7.0 Instrumentation and Control Systems

The information in this section of the reference ABWR DCD, including all subsections and tables, and figures, is incorporated by reference with the following departures and supplements.

Figure 7.1-1 SSLC Self-Test System

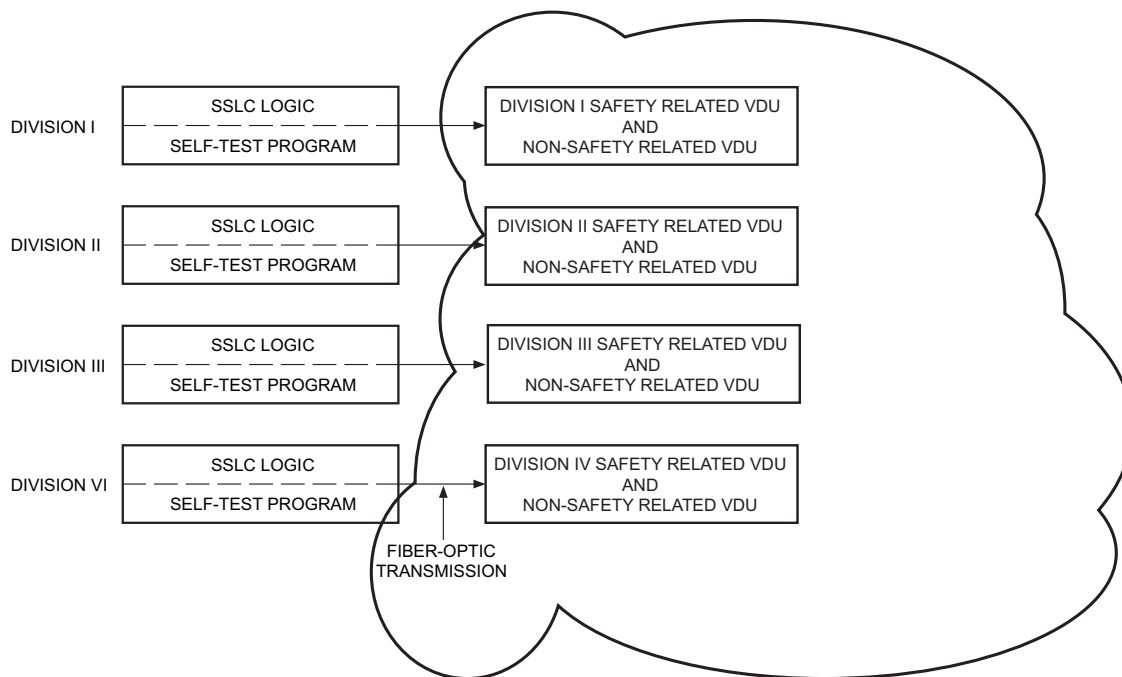
STD DEP T1 3.4-1 (Figure 7.1-1, 7.1-2)

Figure 7.1-2 Assignment of Interfacing Safety System Logic to SSLC Controllers

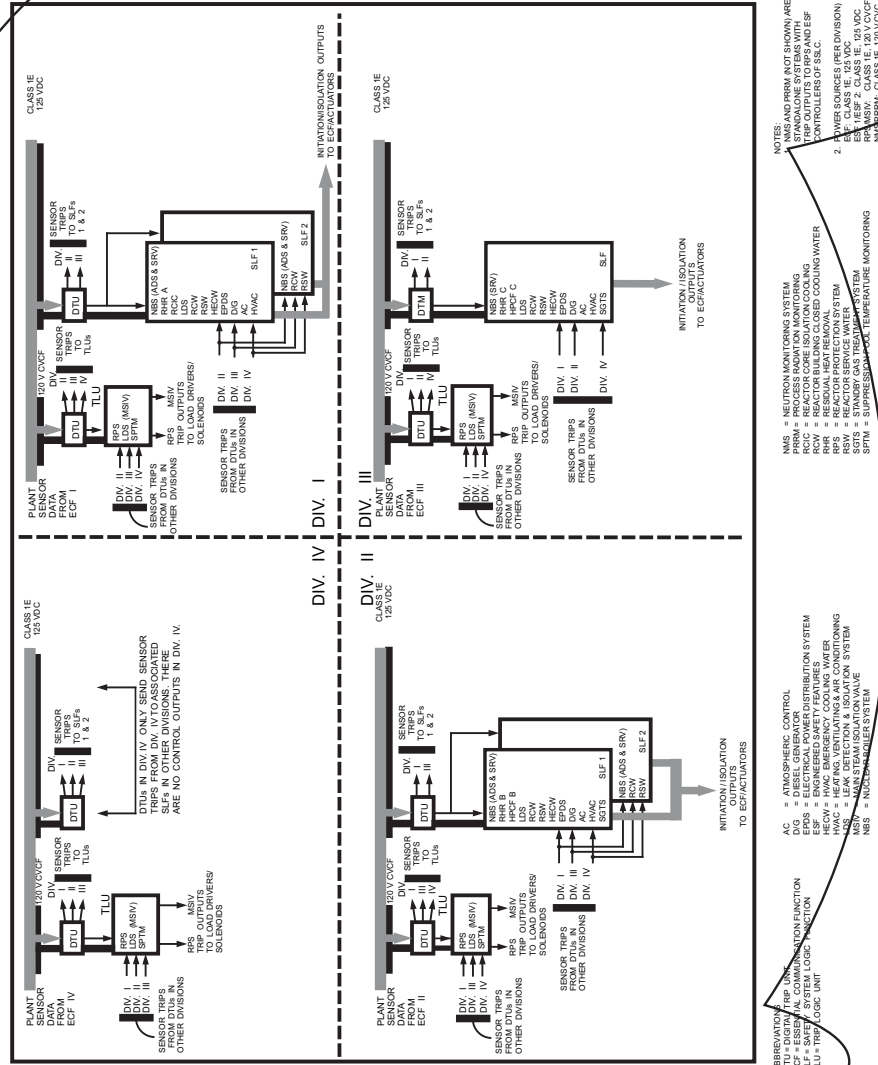
Divisional separation is also applied to the ~~essential multiplexing system (EMS)~~ Essential Communication Function (ECF) for Safety System Logic and Control (SSLC), which provides data highways for the sensor input to the logic units and for the logic output to the system actuators (actuated devices such as pump motors and motor-operated valves). Systems which utilize the SSLC are: (1) Reactor Protection (trip) System; (2) High Pressure Core Flooder System; (3) Residual Heat Removal System; (4) Automatic Depressurization System; (5) Leak Detection and Isolation System; (6) Suppression Pool Monitoring System; and (7) Reactor Core Isolation Cooling System. The equipment arrangement for these systems and other supporting systems is shown in Figure 7.1-2.
